**Submission from  
Northwatch**

**Ontario Power Generation Inc.,  
Pickering Nuclear Generating Station**

Request for a ten-year renewal of its Nuclear Power Reactor Operating Licence for the Pickering Nuclear Generating Station

**Comment on Ontario Power Generation's Application for the  
renewal of its Nuclear Power Reactor Operating Licence (PROL)  
for the Pickering Nuclear Generating Station (NGS)**

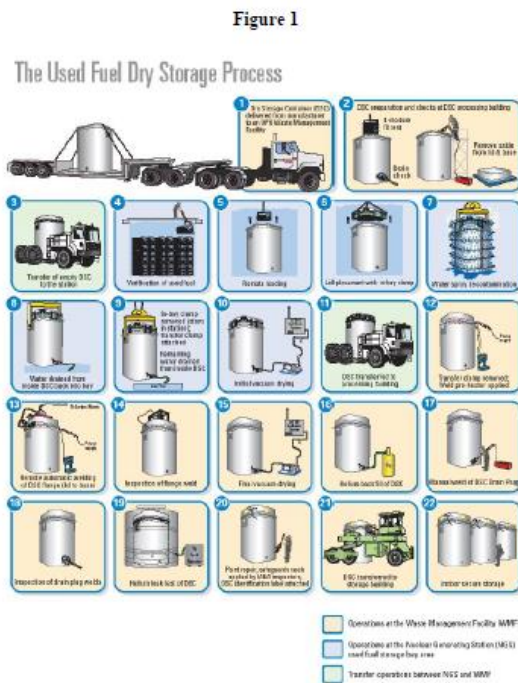
Figure 1 is OPG’s illustration showing the steps involved in placing a loaded DSC into a storage building. Step 11 transports the DSC from the refueling bay to the processing building. The lid is held on the DSC base with a transfer clamp during this movement. Steps 12 through 20 are performed in the processing building. The lid is welded to the DSC base in Step 13. The DSC drain plug is welded shut in Step 17.

Under the proposed plan, DSCs will be transported across unprotected areas before being sealed. Given that it would be easier to remove a transfer clamp holding a lid onto a DSC base or tamper with the unsecured drain plug on a DSC than to breach a sealed DSC, the proposed plan introduces a sabotage vulnerability, unless additional security measures are employed during DSC journeys between protected areas.
